Access Compliance Report

Public Rights-of-Way

Intersection ID: 10028419	Main Street: HIGHGROVE_ST	Cross Street: N/A	Location: SE
ADA ID: 31A2254A32A6	Ramp Type: Perp	Initial Pass/Fail: Fail	Overall Compliance: No
		Severity Score: 25

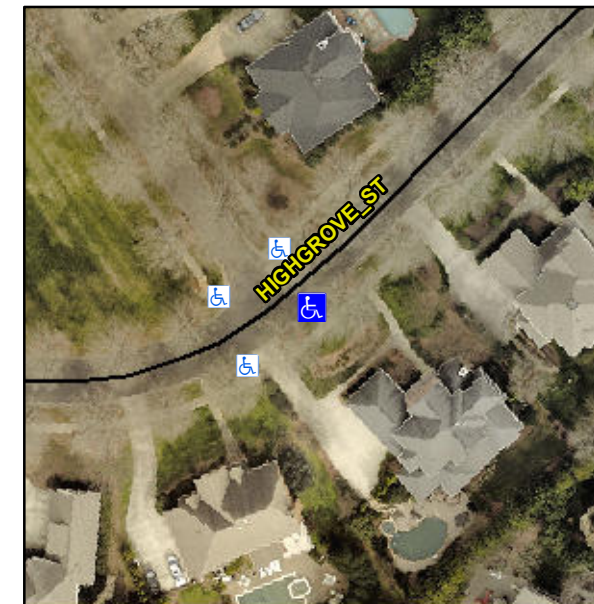
Not Found, R304.2.2

Compliance	Description	Data	Compliance	Description	Data
N/A	Ramp Length (in)	92.0	No	Ramp Slope (%)	12.6
Yes	Ramp Width (in)	56.0	Yes	Ramp XSlope (%)	1.1
N/A	Flare Type LT	N/A	N/A	Flare Type RT	N/A
N/A	Flare Slope LT (%)	N/A	N/A	Flare Slope RT (%)	N/A
N/A	Flare Traversable LT?	N/A	N/A	Flare Traversable RT?	N/A
N/A	Landing Length (in)	N/A	N/A	DWS Provided?	N/A
N/A	Landing Width (in)	N/A	N/A	DWS Contrast?	N/A
N/A	Landing Slope (%)	N/A	N/A	DWS Length (in)	N/A
N/A	Landing X Slope (%)	N/A	N/A	DWS Full Width?	N/A
N/A	Landing Curb? (Y/N)	N/A	N/A	DWS Offset (in)	N/A
N/A	Shared Landing?	N/A			
N/A	Gutter Ponding?	N/A	N/A	Gutter Slope (%)	N/A
N/A	Gutter Lip Ht (in)	N/A	N/A	Gutter X Slope (%)	N/A
N/A	Painted X Walk1?	No	N/A	Painted X Walk2?	N/A
	X Walk 1 Direction	To NW		X Walk 2 Direction	N/A
N/A	X Walk 1 Width (in)	N/A	N/A	X Walk 2 Width (in)	N/A
	X Walk 1 Slope (%)	3.3		X Walk 2 Slope (%)	N/A
	X Walk 1 X Slope (%)	3.2		X Walk 2 X Slope (%)	N/A

Remove & Replace Entire Ramp.
